Access Compliance Report

Public Rights-of-Way

(Curb Ramps)

Intersection ID: 20422	Main Street: W_ARROWWOOD_RD	Cross Street: S_TRYON_ST	Location: NE
ADA ID: 367F4345DB53	Ramp Type: Perp	Initial Pass/Fail: Fail	Overall Compliance: No
Severity Score: 12.5			
Codes/Mitigation Info/Possible Solution		Field Measurements/Component Compliance

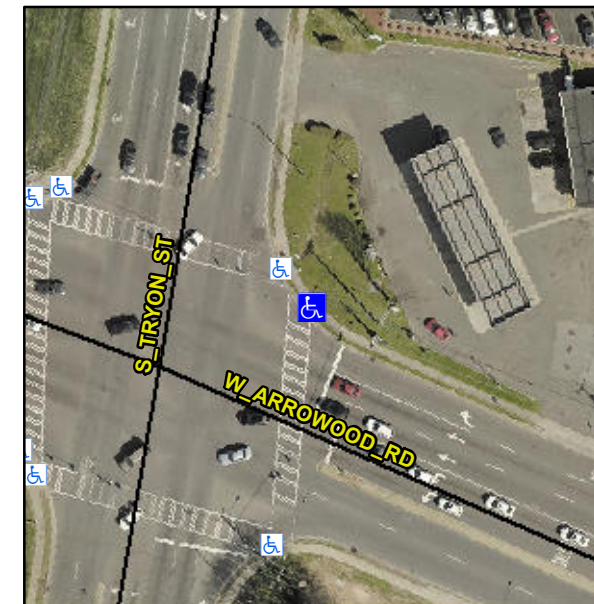
Not Found, R304.2.2

Compliance	Description	Data	Compliance	Description	Data
N/A	Ramp Length (in)	74.0	No	Ramp Slope (%)	9.4
Yes	Ramp Width (in)	50.0	Yes	Ramp XSlope (%)	1.5
N/A	Flare Type LT	N/A	N/A	Flare Type RT	N/A
N/A	Flare Slope LT (%)	N/A	N/A	Flare Slope RT (%)	N/A
N/A	Flare Traversable LT?	N/A	N/A	Flare Traversable RT?	N/A
N/A	Landing Length (in)	N/A	N/A	DWS Provided?	N/A
N/A	Landing Width (in)	N/A	N/A	DWS Contrast?	N/A
N/A	Landing Slope (%)	N/A	N/A	DWS Length (in)	N/A
N/A	Landing X Slope (%)	N/A	N/A	DWS Full Width?	N/A
N/A	Landing Curb? (Y/N)	N/A	N/A	DWS Offset (in)	N/A
N/A	Shared Landing?	N/A			
N/A	Gutter Ponding?	N/A	N/A	Gutter Slope (%)	N/A
N/A	Gutter Lip Ht (in)	N/A	N/A	Gutter X Slope (%)	N/A
N/A	Painted X Walk1?	Yes	N/A	Painted X Walk2?	N/A
	X Walk 1 Direction	To S		X Walk 2 Direction	N/A
N/A	X Walk 1 Width (in)	138.0	N/A	X Walk 2 Width (in)	N/A
	X Walk 1 Slope (%)	3.5		X Walk 2 Slope (%)	N/A
	X Walk 1 X Slope (%)	1.0		X Walk 2 X Slope (%)	N/A

Remove & Replace Entire Ramp.
